2011HCC016 - Wyong Council, DA/308/2011, Residential Flat Building consisting of 42 units and ancillary works under SEPP (Affordable Rental Housing) 2009, 35-41 Wilfred Barrett Drive, The Entrance North

Agenda and Business Paper

JRPP No	2011HCC016
DA Number	DA/308/2011
Local Government Area	Wyong Shire Council
Proposed Development	Demolition of an existing dwelling-house and the construction of six (6) residential flat buildings containing a total of forty-two (42) units and associated works under State Environmental Planning Policy (Affordable Rental Housing) 2009
Street Address	No 35-41 Wilfred Barrett Drive, The Entrance North
Applicant/Owner	Celex Pty Ltd Mr H J Clifford and Mr L W Clifford
Number of Submissions	89 plus a petition with 473 signatures
Recommendation	Approval with Conditions
Report by	Jenny Webb, Senior Development Planner

Assessment Report and Recommendation

Figure 4 – Approximate extent of Provisional High Hazard flooding

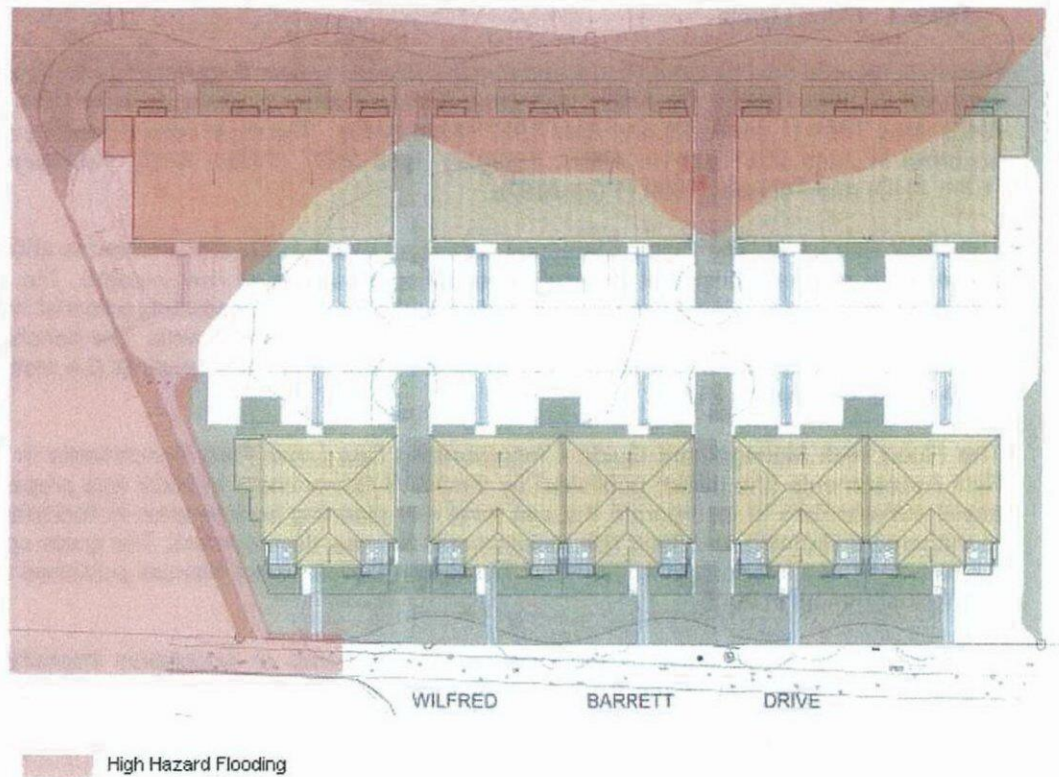
The policy requires categorisation of flood hazards in accordance with the NSW Floodplain Development Manual, which details the process to determine flood hazard category. The process involves firstly evaluation of hazard level from pure hydraulic principles, and then refining the hydraulic hazard category in light of other relevant factors affecting the safety of individuals to establish the true flood hazard category. The hazard category from pure hydraulic principles is considered to be a combination of high hazard flood storage and low hazard flood storage. Figure 4 illustrates an interpretation of high hazard flooding overdrawn on the architectural plans.

As the application of the policy requires determination of true flood hazard category, this was assessed by refining the hydraulic hazard category. A summary of this assessment is provided below:

Based on the flood assessment, and property modification measures, the true flood hazard category applicable to the development is considered to be wholly low hazard flooding. The development controls under Council's Flood Prone Land Development policy permit New Development in Low Hazard category flooding, subject to a merits assessment. Having considered flooding hazard, including predicted sea level rise, the application can be supported on floodplain management grounds.
